# **CITY OF MACKINAC ISLAND**

### **HISTORIC DISTRICT COMMISSION**

Re: **CHIPPEWA HOTEL WINDOWS ADDITION**  
Design Review

**DESIGN REVIEW**

SHEET TITLE:  
**BUILDING ELEVATION**

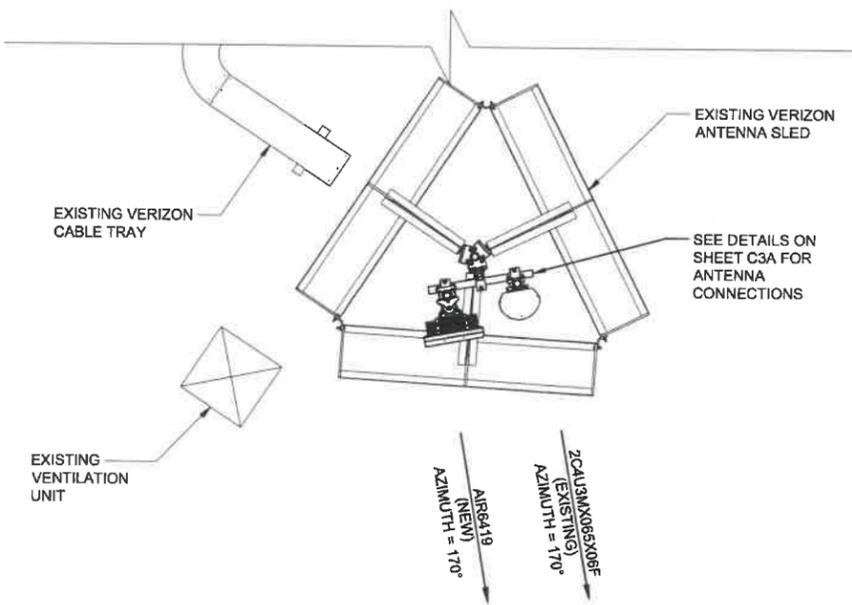
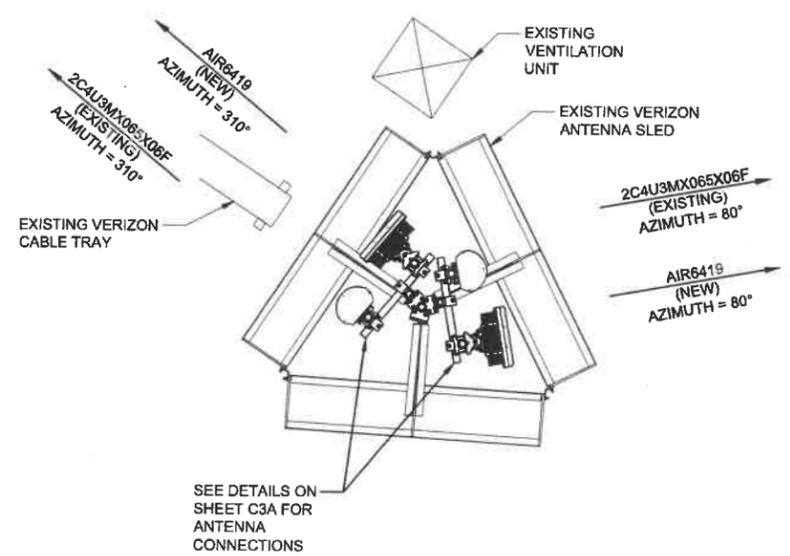
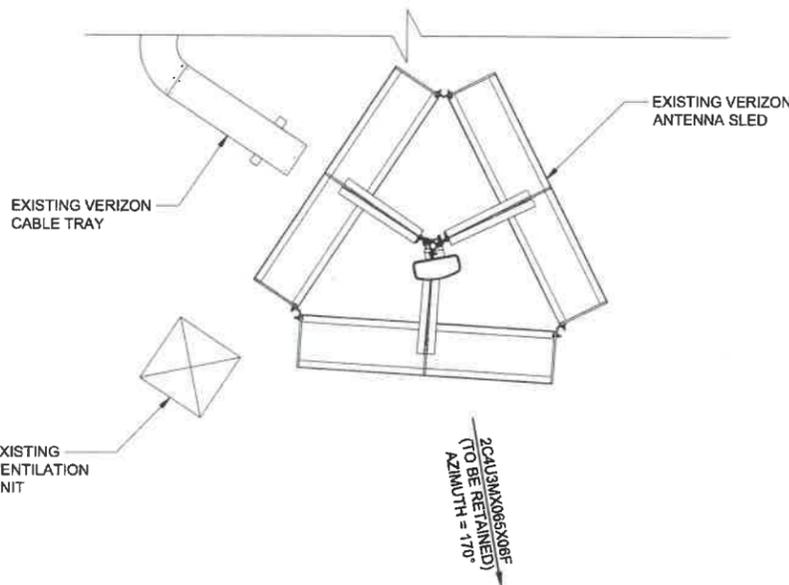
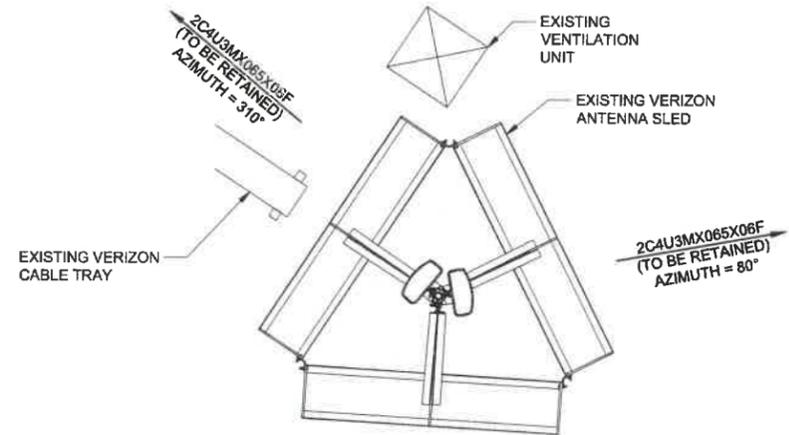
The Verizon towers are the two closest to the center of the roof (AT&T towers are the two closest to each end of the roof). The existing antenna sleds (roof-mounted towers) are proposed to be outfitted with three new replacement antennas, the northern-most tower with two, and the other tower with one antenna. The height of the towers would not change, but the antenna equipment itself would entail more elements and be larger in size.

The relationship of the proposed antenna replacements to the rest of the resource are, and would be, contrasting elements to the historic architectural features of the Hotel. But being on the roof, they would minimally change their relationship to the building and to the district.
